SANDY SPRINGS
GEORGIA

P&Z STAFF REPORT

Board of Appeals Meeting, December 10, 2019

Case: **V19-0022 – 0 Glenridge Drive**
Staff Contact: Madalyn Smith (msmith@sandyspringsga.gov)
Report Date: December 3, 2019

1
AA1.19B
LEVEL G4 - LOADING DOCK REFERENCE PLAN - D.C. 8.1.10.C.3
SCALE: 1/16" = 1'-0"

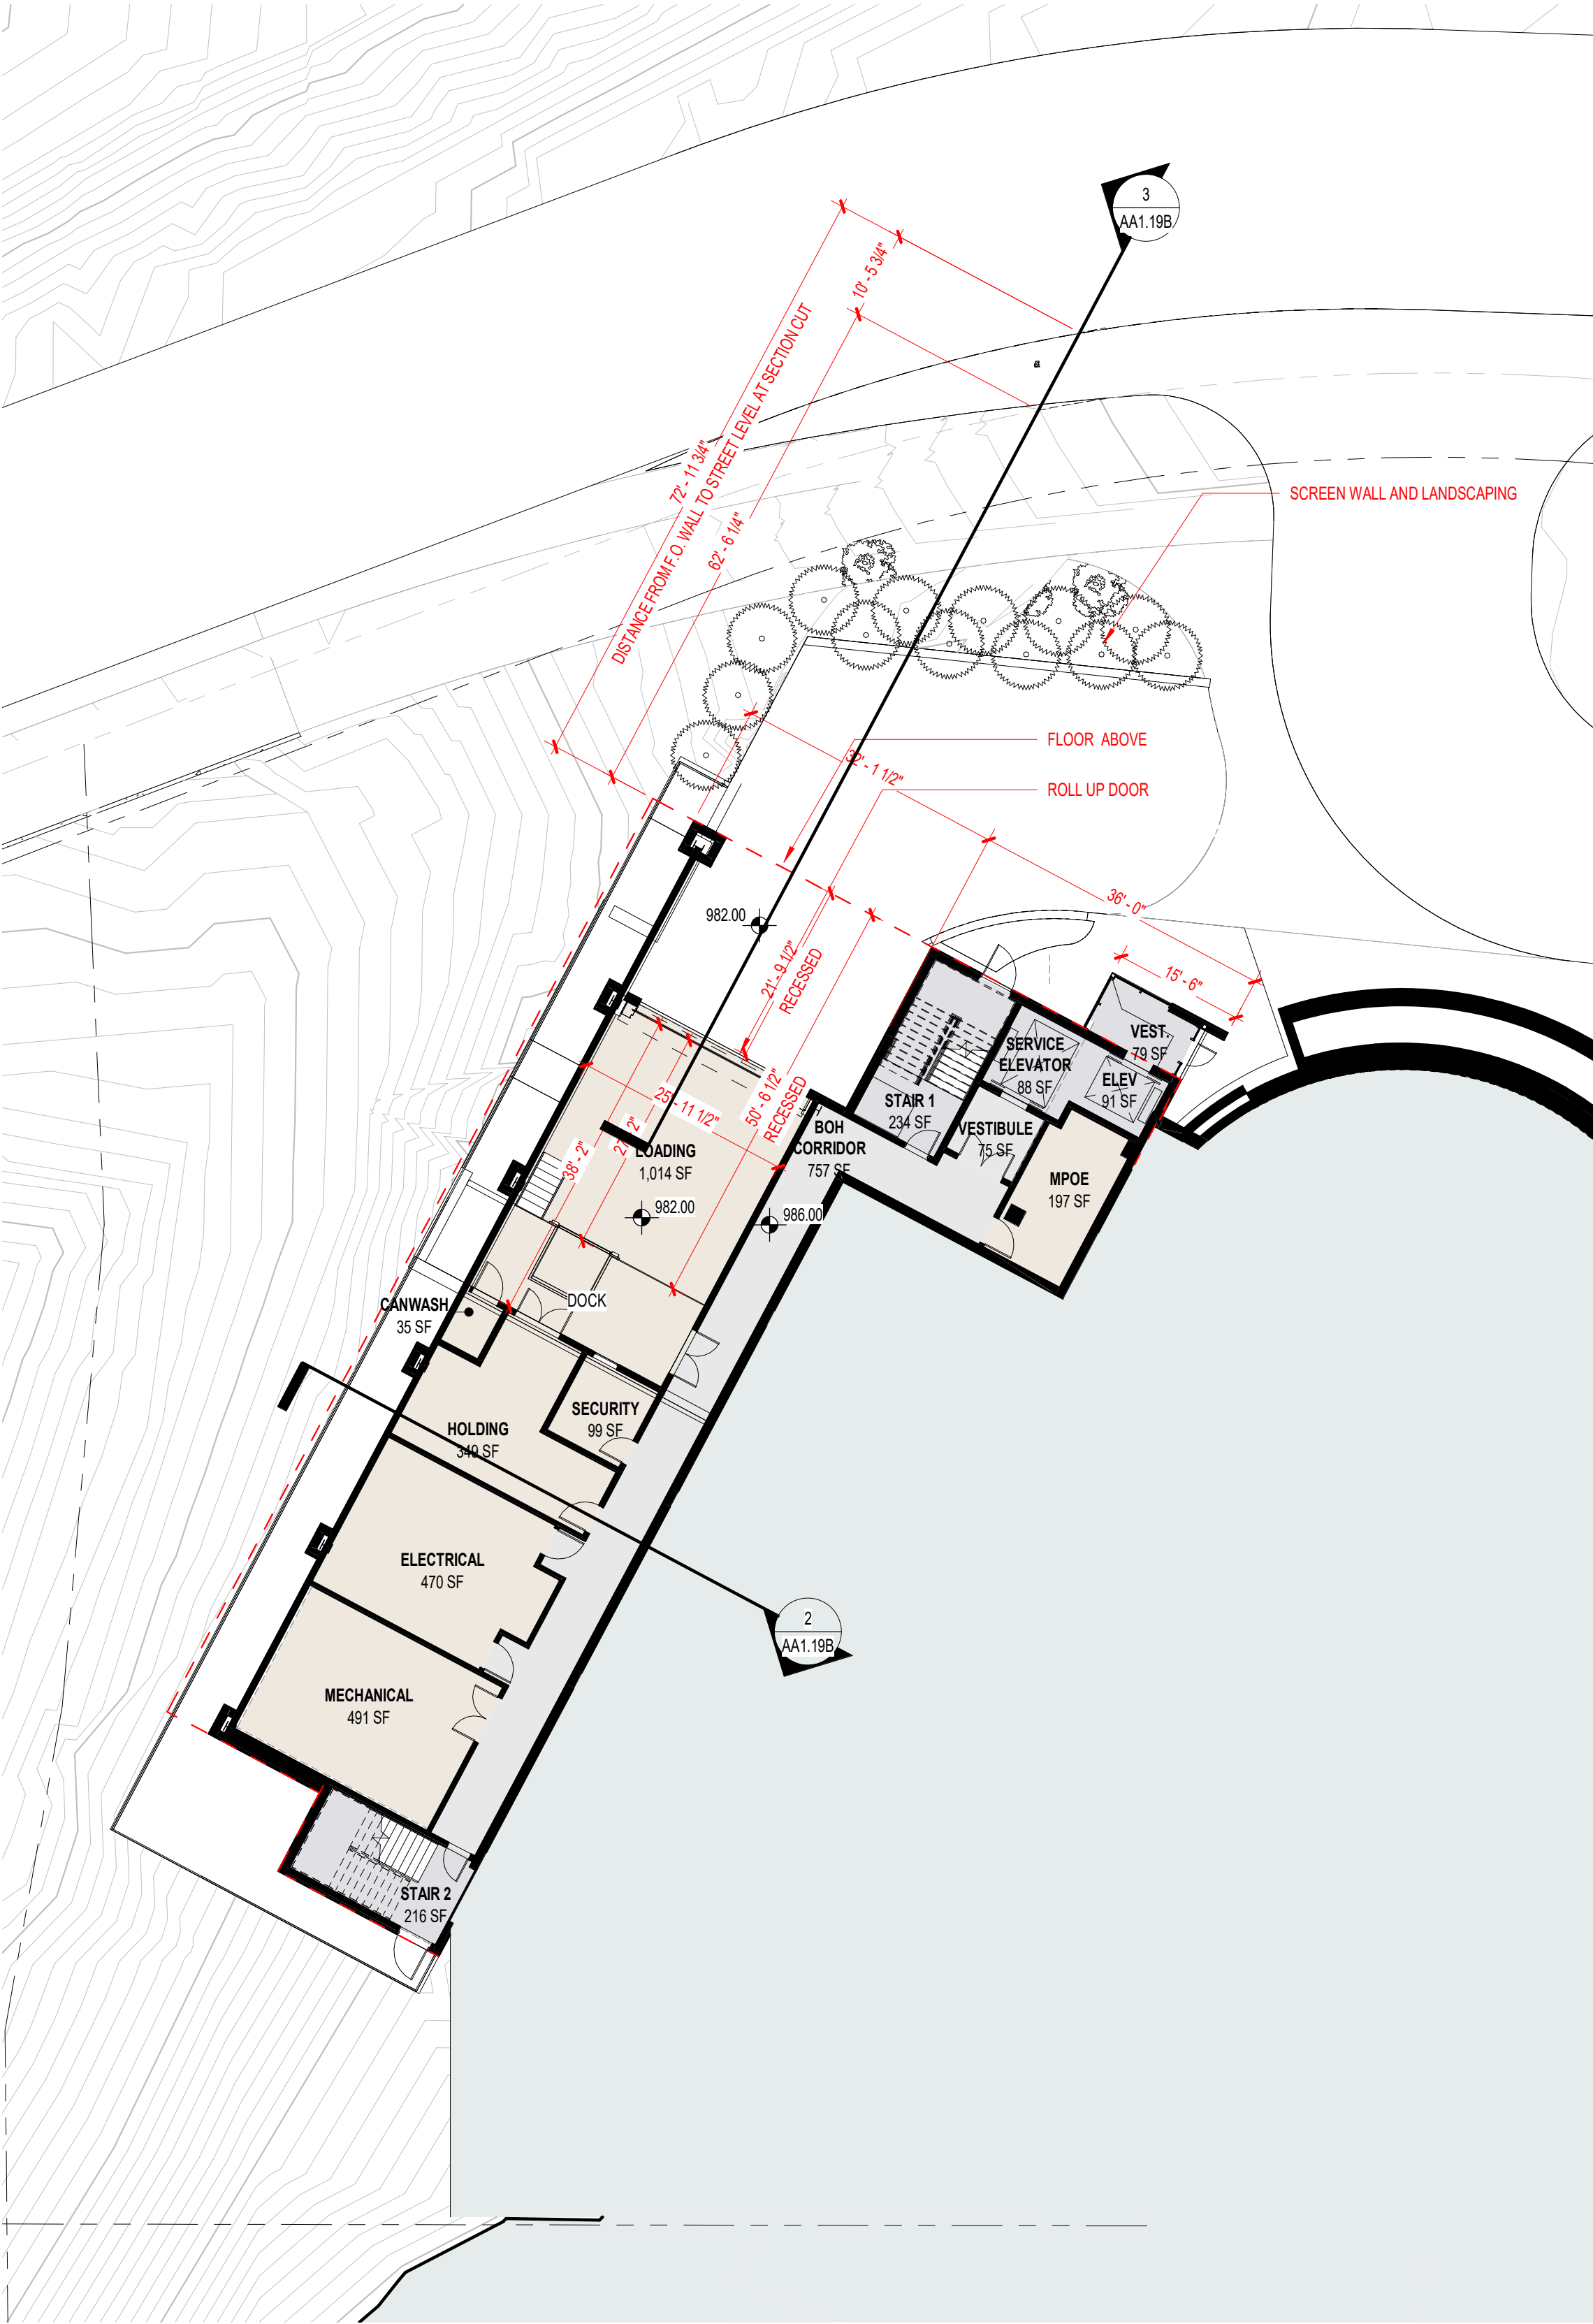
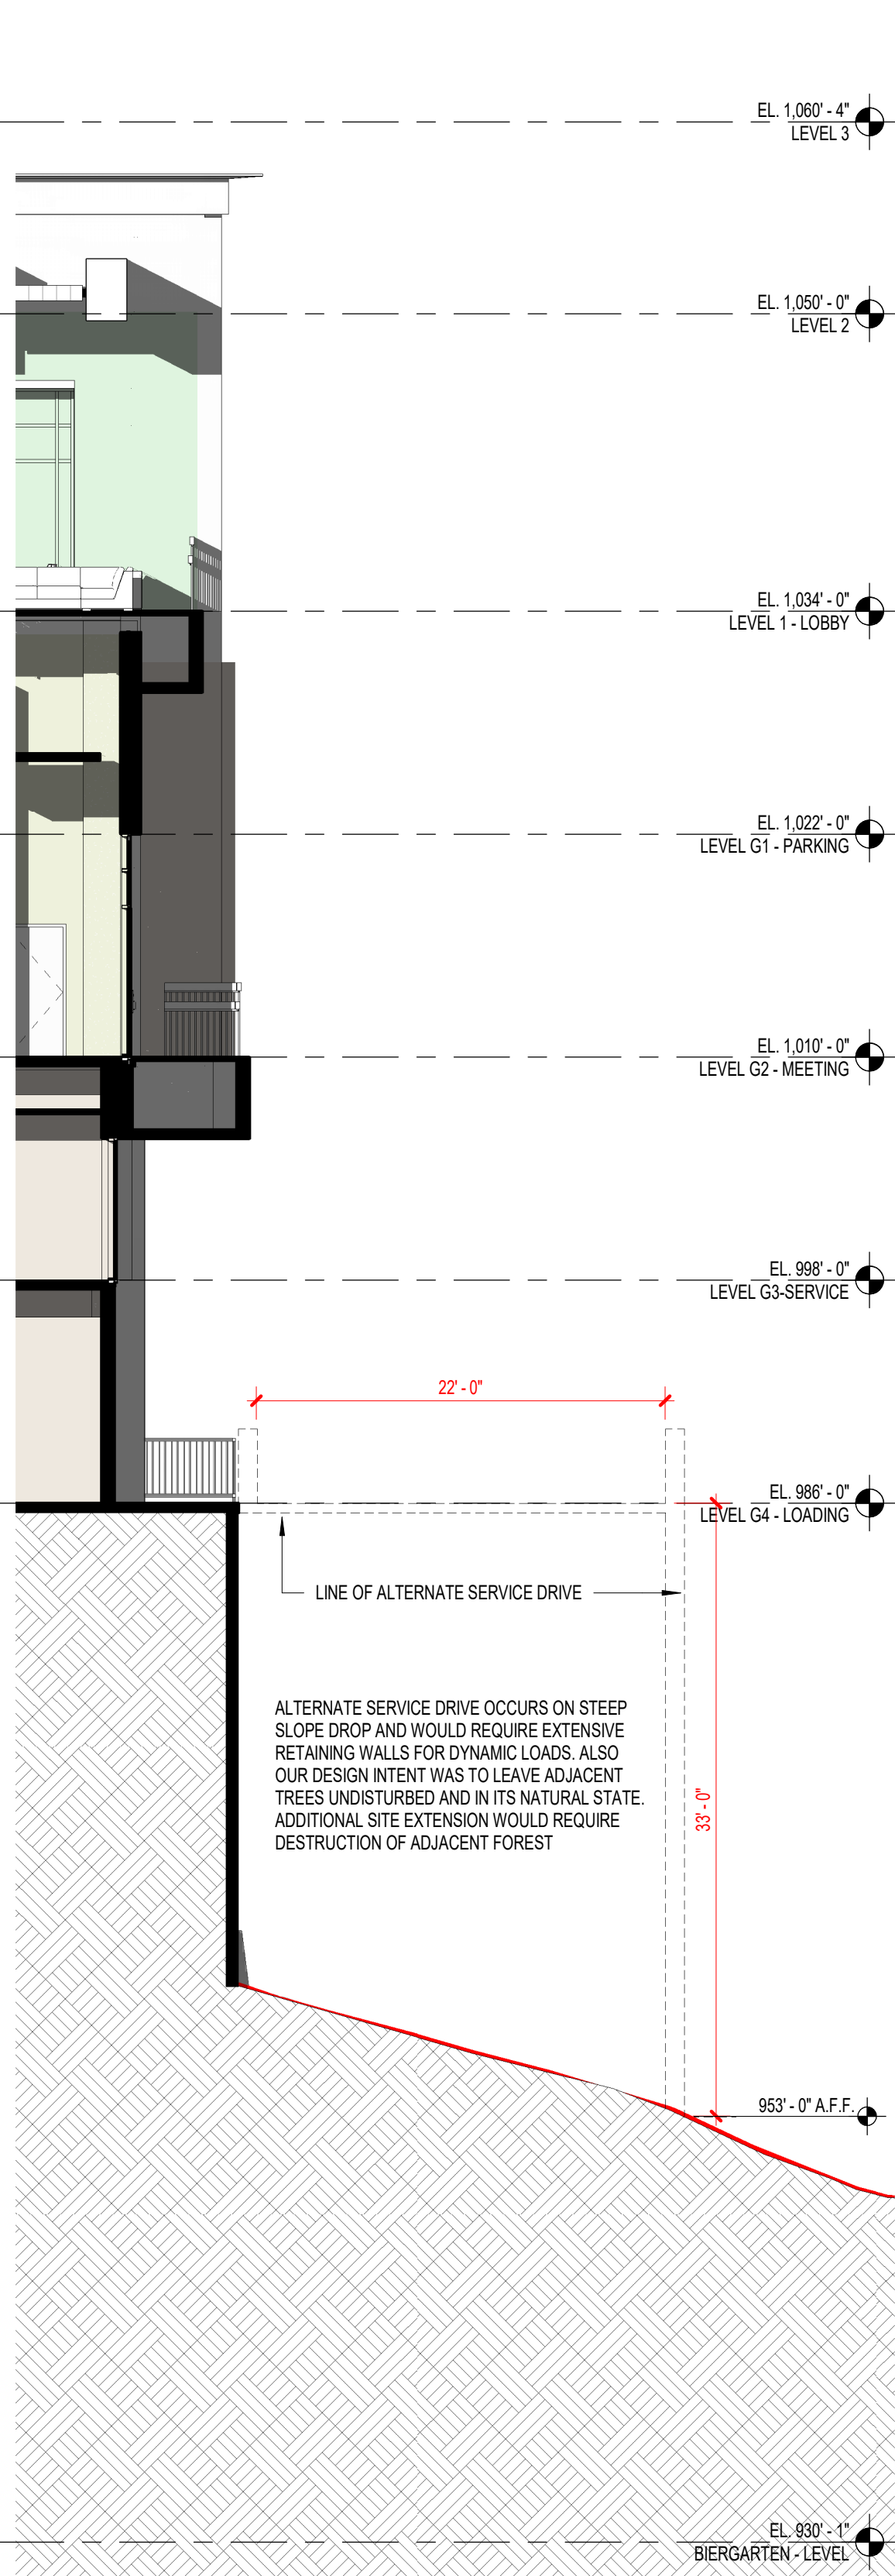
There are extraordinary and exceptional conditions due to the shape and topography of the site. While the lot is fairly large at 5.2 acres, it is only around 200 feet wide. Much of it is unbuildable due to the presence of state waters, floodplain, and wetlands. The portion that is buildable, is a large, steep hill. The narrowness of the property and the topography limit the options for placement of the loading dock. Adherence to this section of the Development Code would require the loading dock to be placed to the rear of the building, which would not eliminate a Variance request because accessing the rear would require the construction of retaining walls ranging from 10-20 feet in height. The retaining walls would require a Variance from either the height limitation of 8 feet, or if the wall is tiered it would require a Stream Buffer Variance. As noted by the City architect, it would also put the loading dock activities adjacent to residential uses. The applicant proposes to locate the loading dock in the most logical place on the site. Therefore, staff recognizes a hardship.

The location and orientation of the loading dock also seems to be the only practical solution. The alternative location appears to create much more site disturbance, create difficult access issues and put the loading dock activities directly adjacent to a residential use.

1. The location of the loading dock be substantially similar to that shown on the “*Mayson House Variance Issuance*” plans received October 28, 2019 and subsequent amendments received November 6, 2019.
